RE: Docket No. 424: Interstate Reliability Project

Development & Management Plan Change Notice Request:

Structure Modifications Pursuant to Federal Aviation Administration Conditions of Determination

for Aviation Warning and Markings - Towns of Mansfield, Brooklyn, and Pomfret

Exhibit FAA-1: FAA Light and Solar Panel Arrangement on Transmission Structure

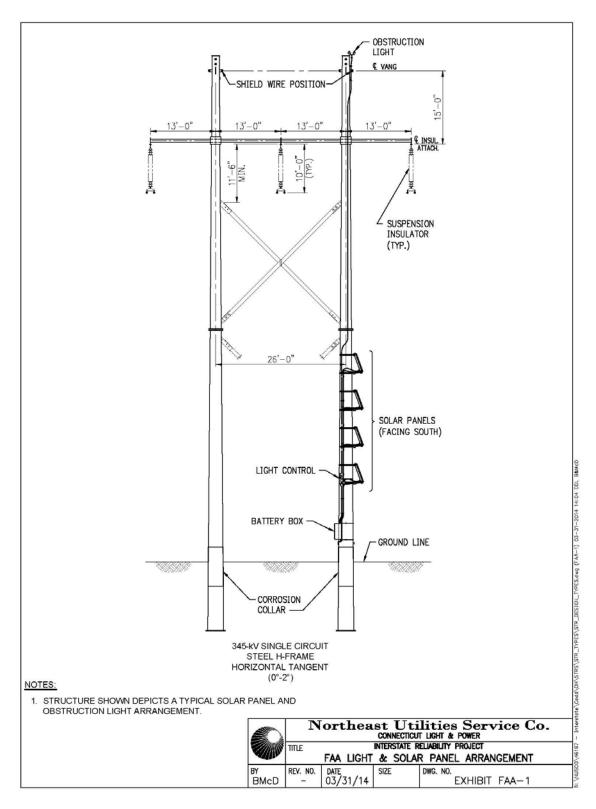
Specifically, CL&P proposes to install steady-state red obstruction lights on eight new transmission line structures near Windham Airport and 10 new transmission line structures near Danielson Airport. Marker balls will be placed on shield wires along spans near some of these structures. Further, to conform to FAA recommendations, CL&P slightly reduced the height of two new structures.

For reference, Figure 1 includes photographs of aviation warning lights recently installed on new transmission line structures on the Massachusetts portion of the Greater Springfield Reliability Project. The warning lights planned for the Interstate transmission line structures will be the same, or similar to, these lights. Exhibit FAA-1 illustrates the design of the aviation warnings and solar panels. Figure 2 provides representative photographs of marker balls on transmission lines.
